Bidding and Contract Requirements
Addendum No. 1

Date: June 2, 2021
To: Plan Holders
Subject: Addendum No. 1 to the Bidding Documents for: ITB No. 2021-003

Satellite Jail HVAC Replacement Project
502 South Lierman Avenue
Urbana, Illinois

SCALE:	DRAWN: JMD	APPROVED: RCVN	SHEET: M-202
	DATE: MAY 5, 2021		
	ISSUED FOR BID		
	PRODUCT: GHR # 7253

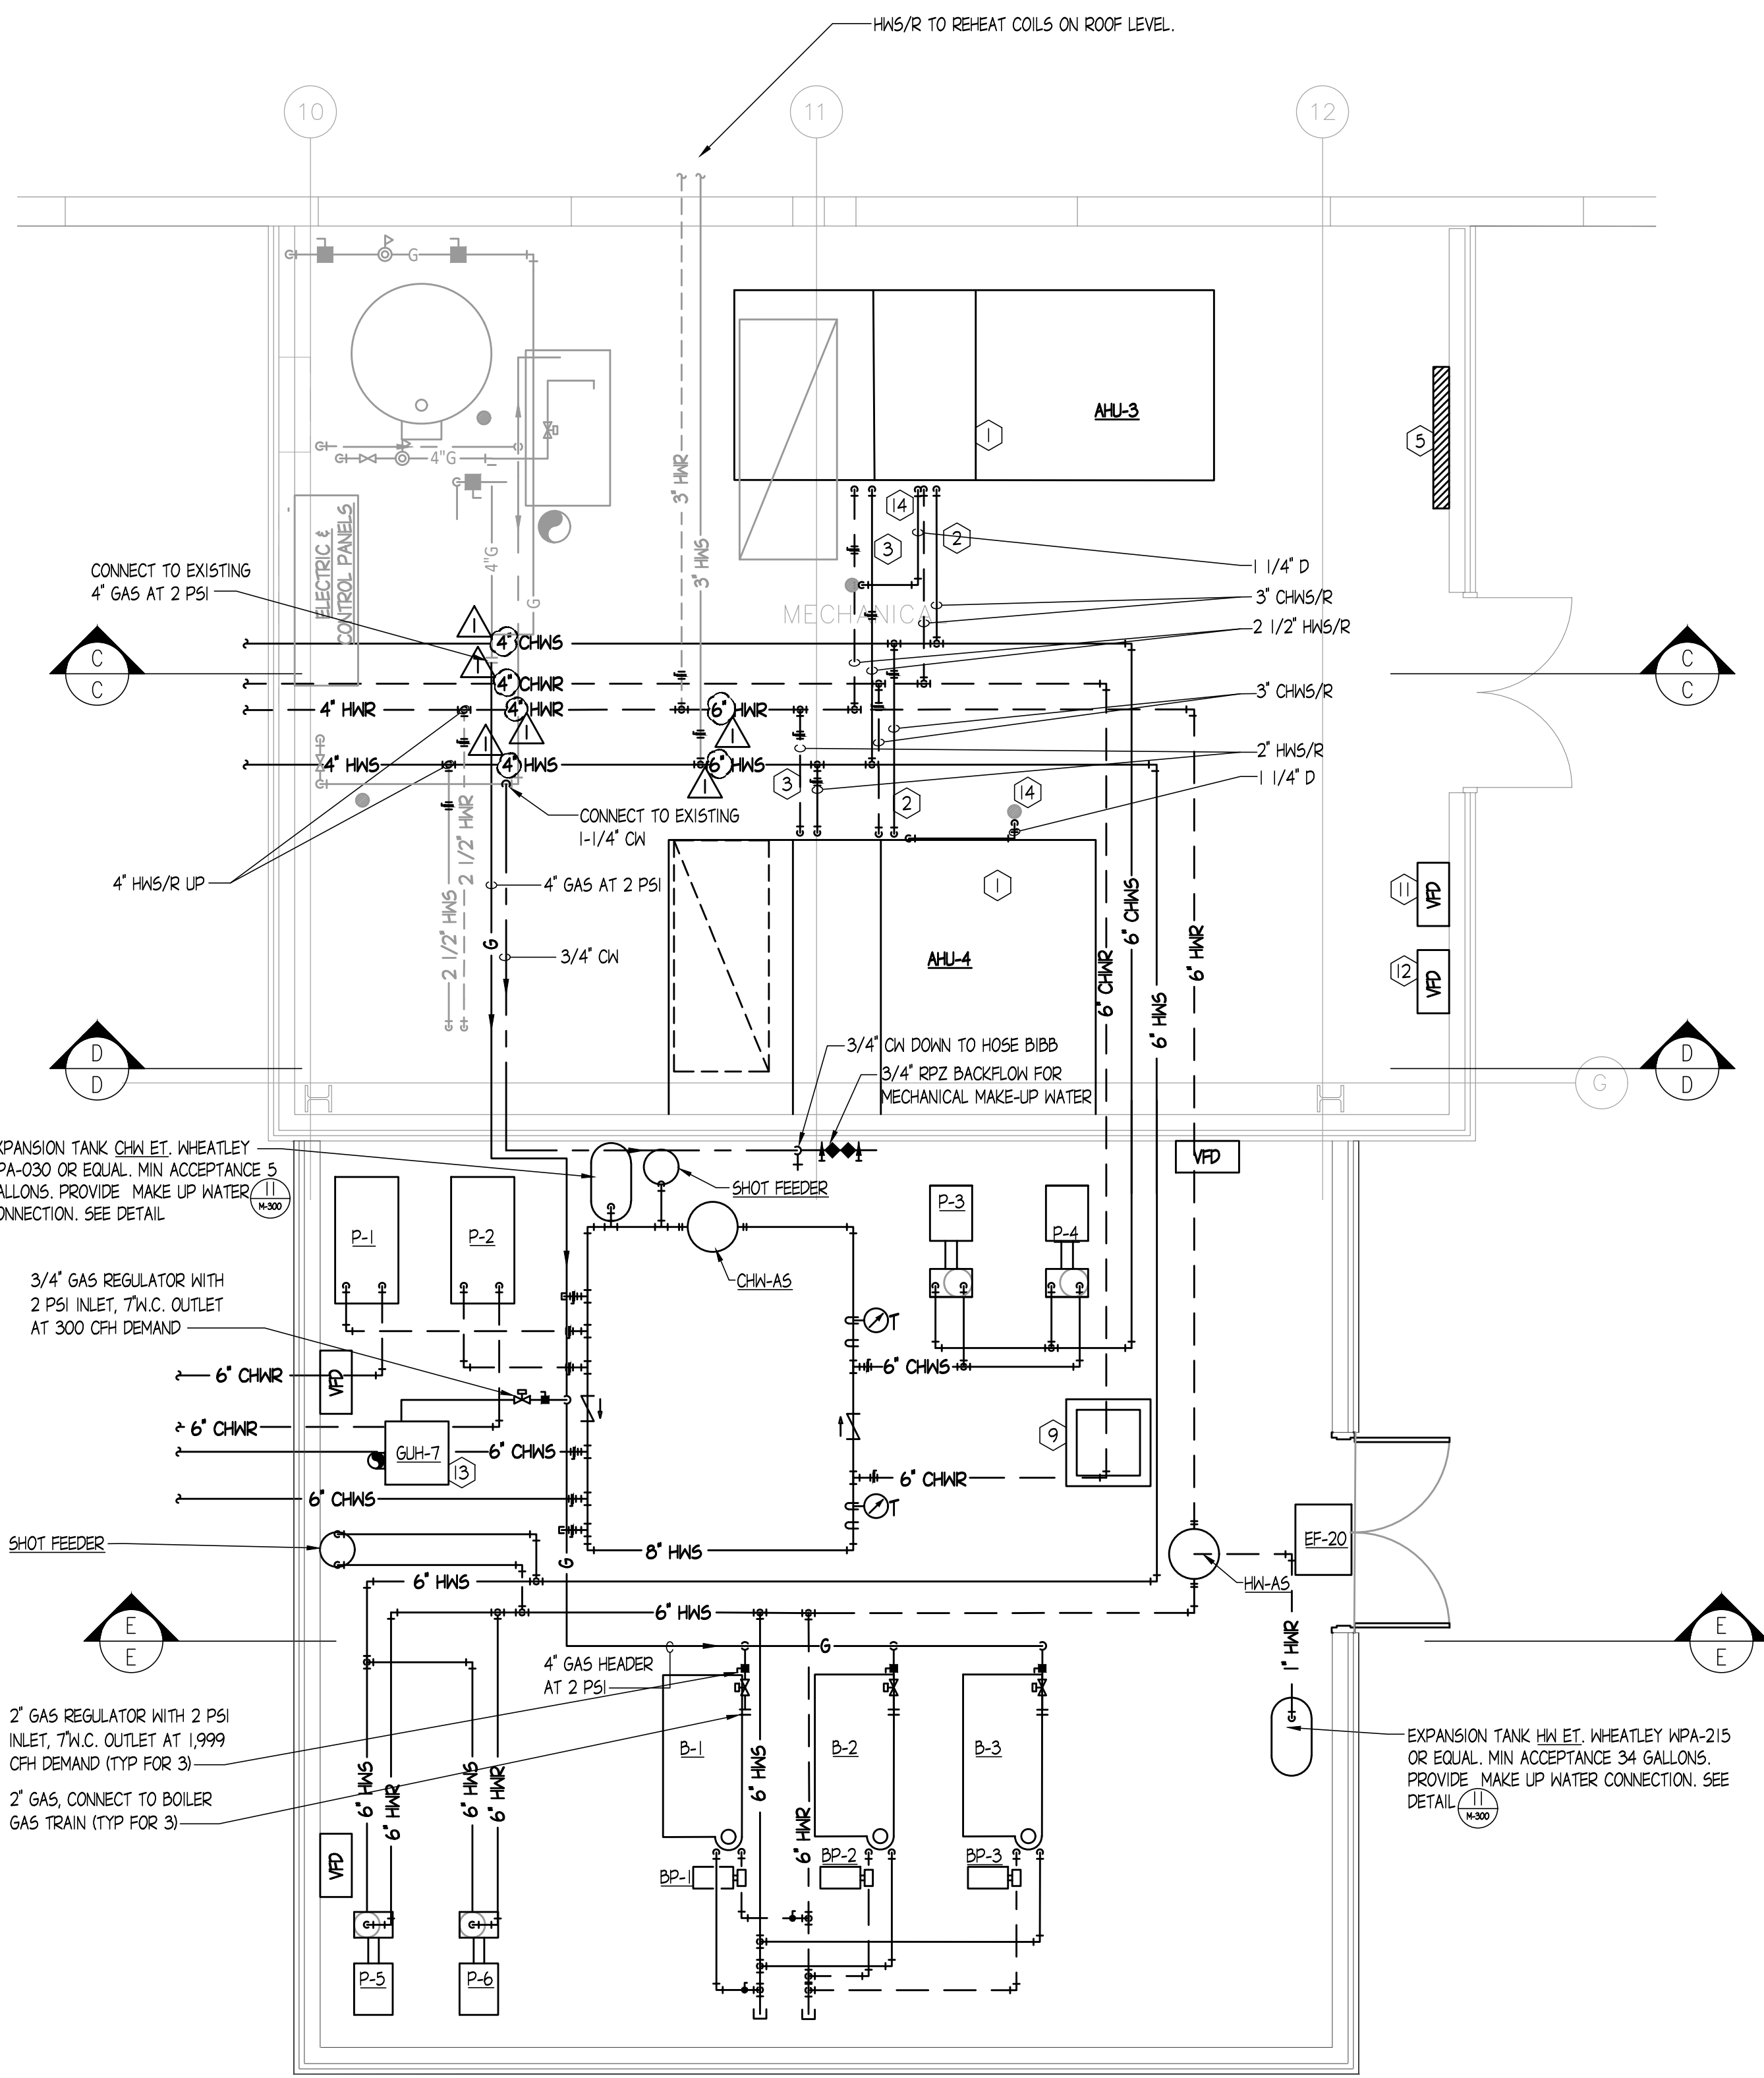
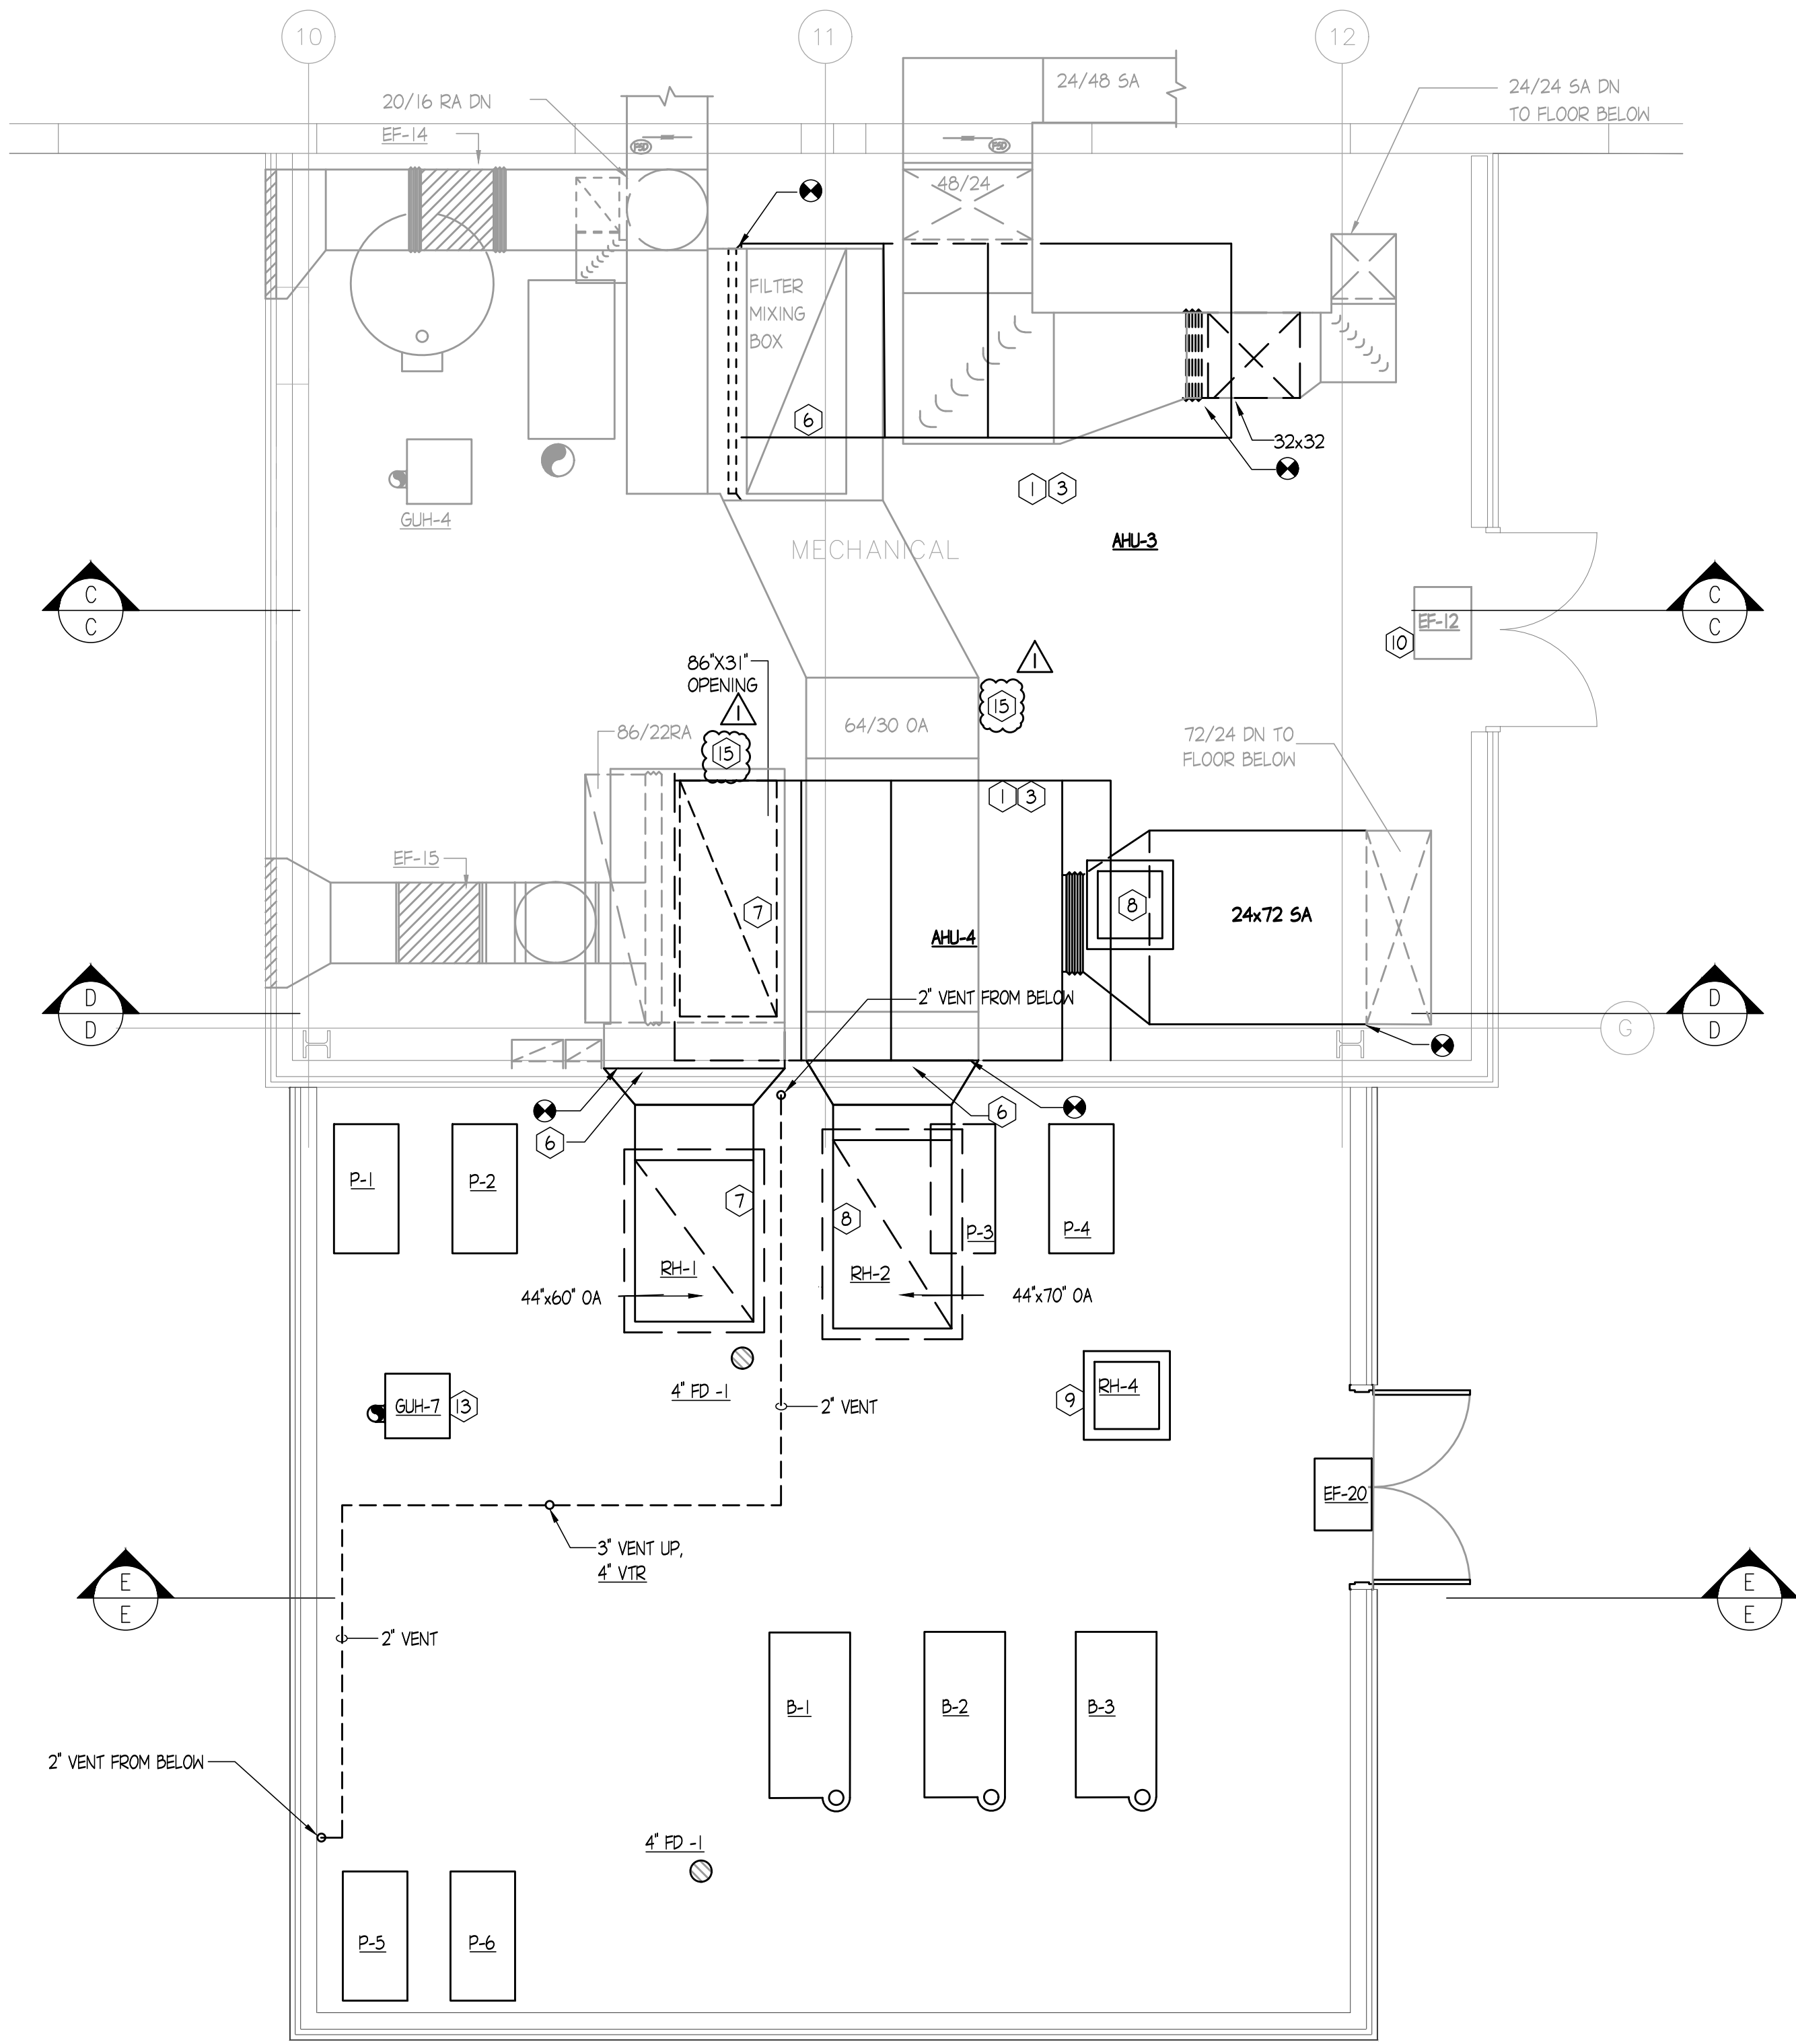
4. Sheet M-201 - ENLARGED FLOOR PLANS - HVAC
 - a. REVISE piping sizes. See attached sheet.
 - b. ADD note for installation of Air Measuring Stations. See attached sheet.
5. Sheet M-202 - ENLARGED FLOOR PLANS - NEW PENTHOUSE - HVAC
 - a. REVISE piping sizes. See attached sheet.
 - b. ADD note for installation of Air Measuring Stations. See attached sheet.
6. Sheet M-400 - SCHEDULES - HVAC
 - a. REVISE AHU schedule. See attached sheet.
7. Sheet M-500 - CONTROLS DIAGRAMS - HVAC
 - a. REVISE control drawing details. See attached sheet.
 - b. ADD note to read "Note: Coordinate base bid contract work with control contract work per control drawings."
8. Sheet S-100 - STRUCTURAL DETAILS
 - a. ADD penthouse structural steel details. See attached sheet.
9. Sheet E103 - ROOF PLAN - ELECTRICAL
 - a. REVISED keyed note regarding panel 'PH2A' to no. 13. There had been (2) keyed notes numbered no. 14.

11. NEW VPD SERVING AHU-3.
12. NEW VPD SERVING AHU-4.
13. INSTALL NEW UNIT HEATER.
14. NEW CONDENSATE PIPING FROM AHU TO FLOOR DRAIN.
15. AIR MEASURING STATION PROVIDED BY TEMPERATURE CONTROL CONTRACTOR AND INSTALLED BY MECHANICAL CONTRACTOR.
